SUBJECT: Big Rock Point, "Big Rock Point License Termination Plan," Revision 3

Big Rock Point
Dockets 50-155 and 72-043
License No. DPR-6

Big Rock Point License Termination Plan Revision 3 Summary

Big Rock Point License Termination Plan Revision Matrix

Figure 1-1. Big Rock Point ISFSI Location In Relation
To The Site Map At The Time Of LTP Submittal

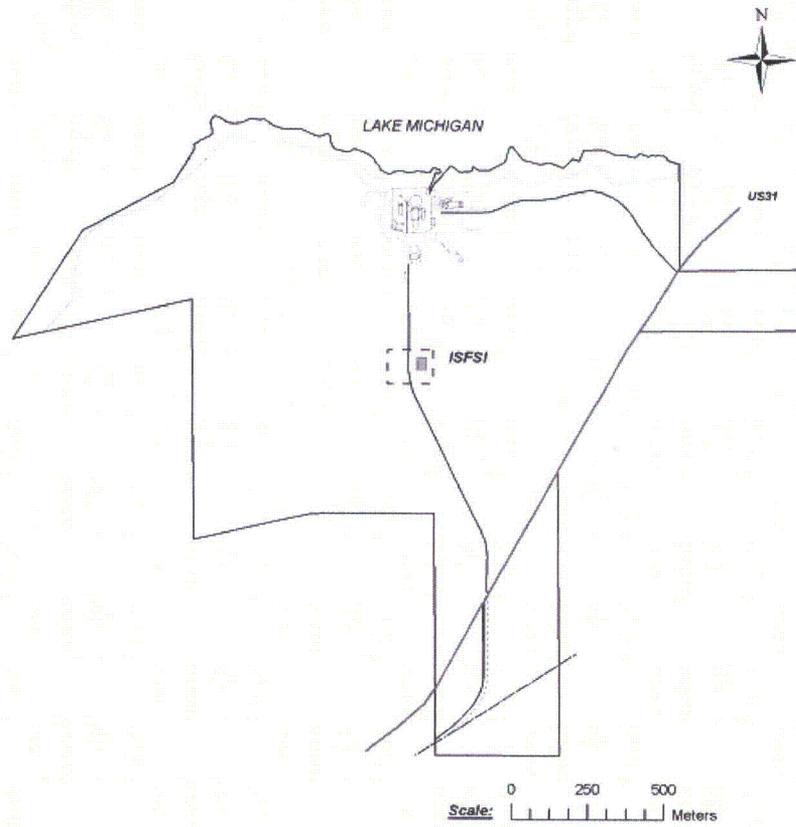
| Section | Page | Revision | Basis |
|----------------|-------------|---|---|
| Fig. 1-1 | 1-11 | Changed the Figure title from “Big Rock Point Owner Controlled Area” to “Big Rock Point ISFSI Location In Relation To The Site Map At The Time Of LTP Submittal.” | Revised the title of the figure to reflect the completion of the first phase of decommissioning. |

Figure 1-2. Big Rock Point ISFSI Non-Impacted Land Areas

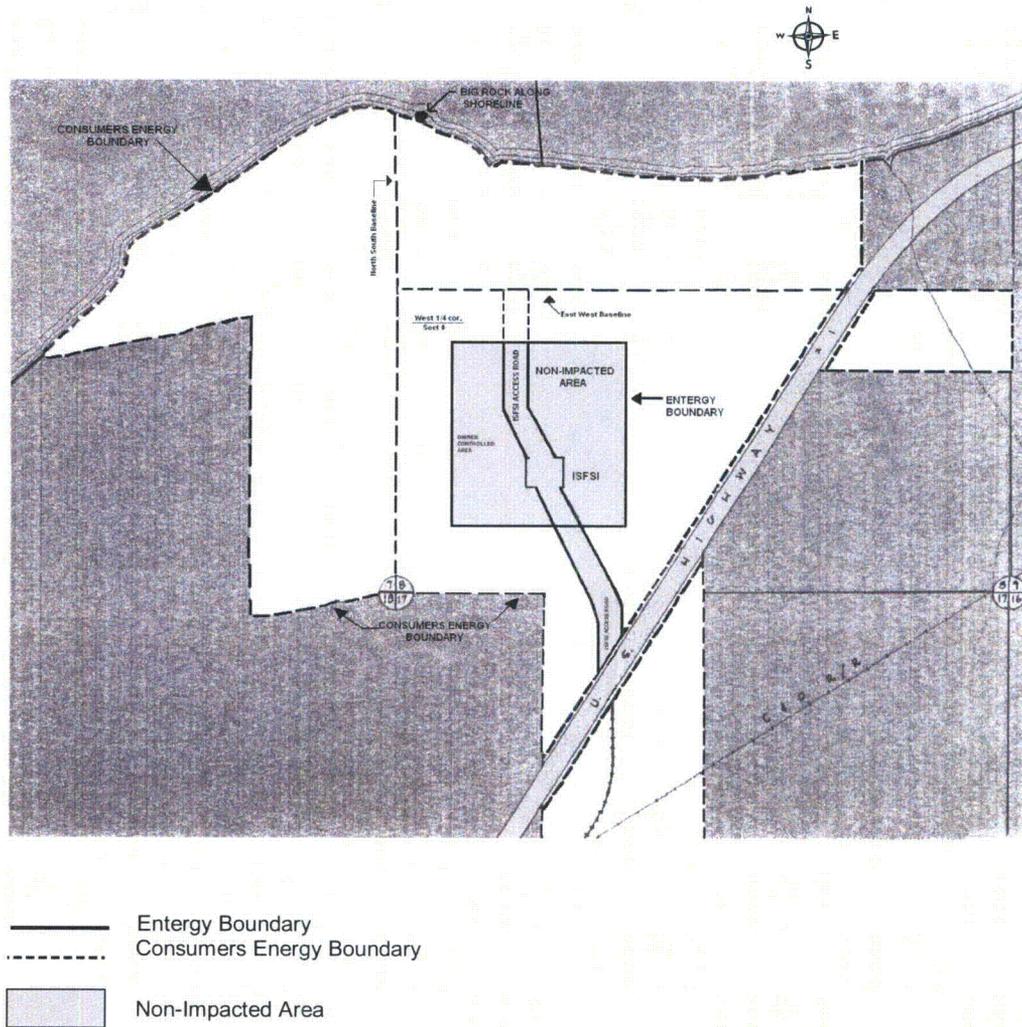
| Section | Page | Revision | Basis |
|----------------|-------------|---|---|
| Fig. 1-2 | 1-12 | Added Big Rock Point ISFSI Non-Impacted Land Areas Map. | Added the map to provide a visual depiction of the Entergy Palisades LLC BRP ISFSI property boundary in relation to the Consumers Energy property boundary. |

Figure 8-1. Big Rock Point Site Boundary Map

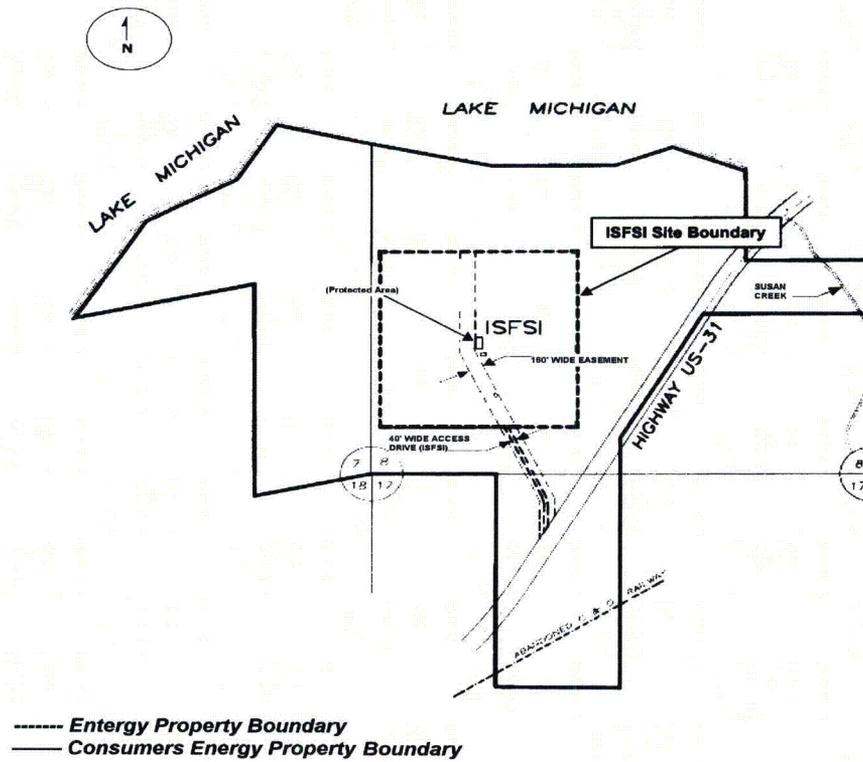
| Section | Page | Revision | Basis |
|----------------|-------------|---|---|
| Figure 8-1 | 8-29 | Revised the figure. | Removed the former power reactor facility and added the ISFSI site boundary. |

Figure 8-3. Aerial Image of BRP Prior to First Phase of Decommissioning

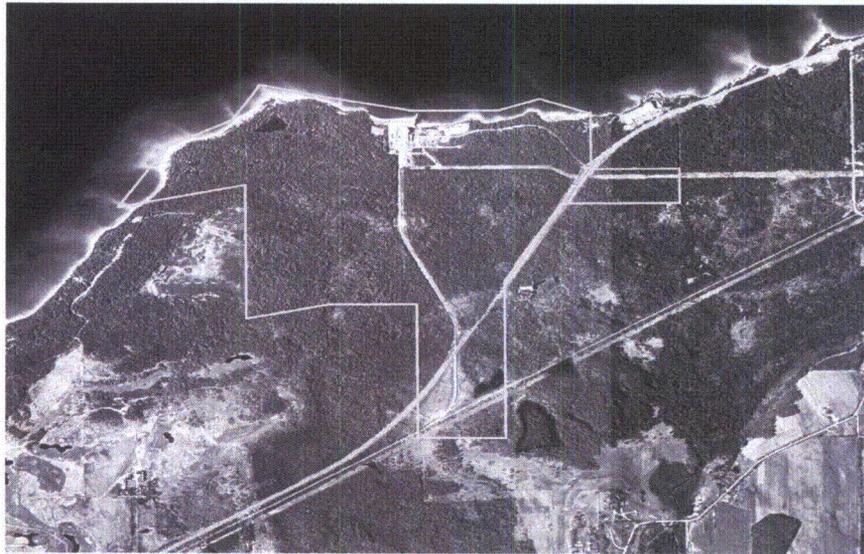
| Section | Page | Revision | Basis |
|----------------|-------------|---|---|
| Figure 8-3 | 8-31 | Renumbered the figure. | The figure was previously Figure 8-2. |

Figure 8-5. Land Use Within Five Miles of Big Rock Point

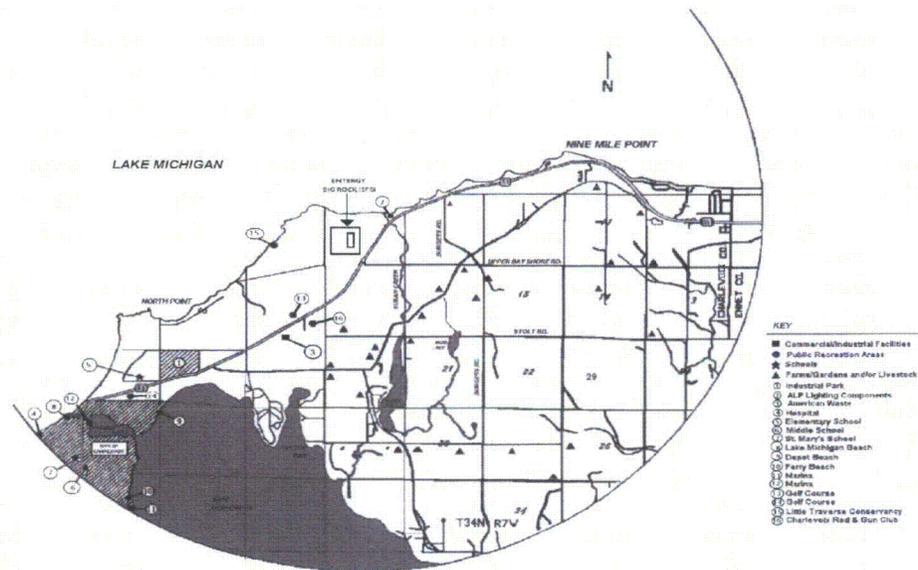
| Section | Page | Revision | Basis |
|----------------|------------------------|------------------------------------|---|
| Figure 8-5 | 8-33 | Revised and renumbered the figure. | The figure was previously Figure 8-3. Revised the figure to remove the Consumers Energy property boundary and add the Entergy ISFSI property boundary. Updated the key listing. |

Figure 8-7. USGS Seismic History for Michigan (1990 – 2006)

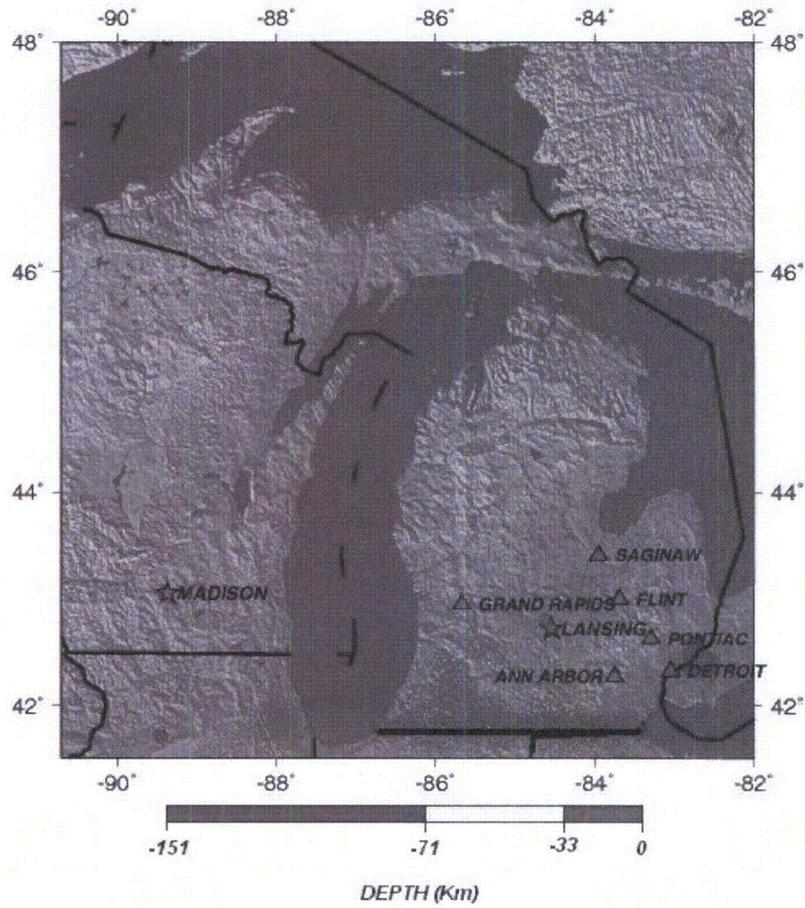
| Section | Page | Revision | Basis |
|----------------|------------------------|------------------------------------|---|
| Figure 8-7 | 8-35 | Revised and renumbered the figure. | The figure was previously Figure 8-5. Updated the figure with the most recent information from the United States Geological Survey (USGS). |

Figure 8-8. Big Rock Point Soil Types

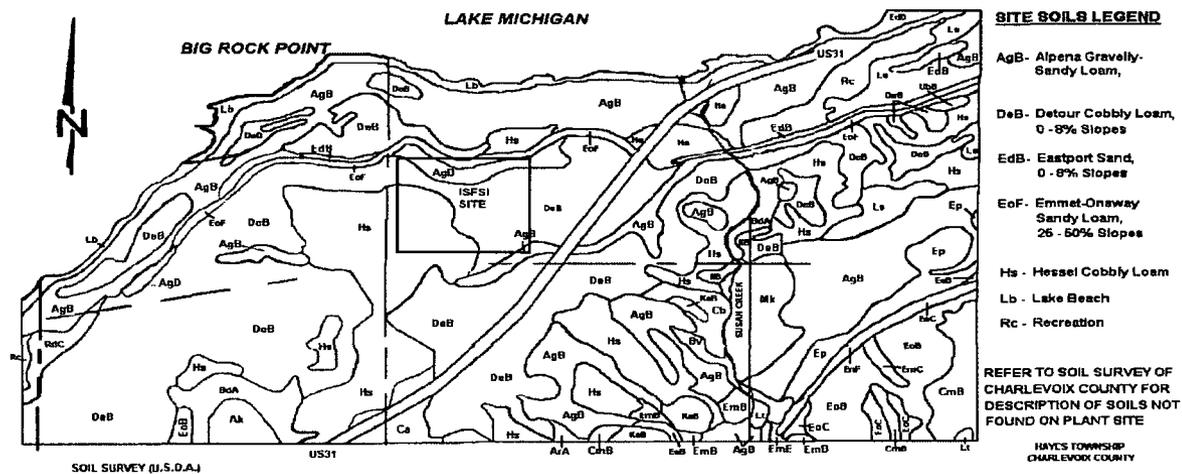
| Section | Page | Revision | Basis |
|----------------|------------------------|------------------------------------|---|
| Figure 8-8 | 8-36 | Revised and renumbered the figure. | The figure was previously Figure 8-6. Revised the figure to remove the Consumers Energy property boundary and add the Entergy ISFSI property boundary. |
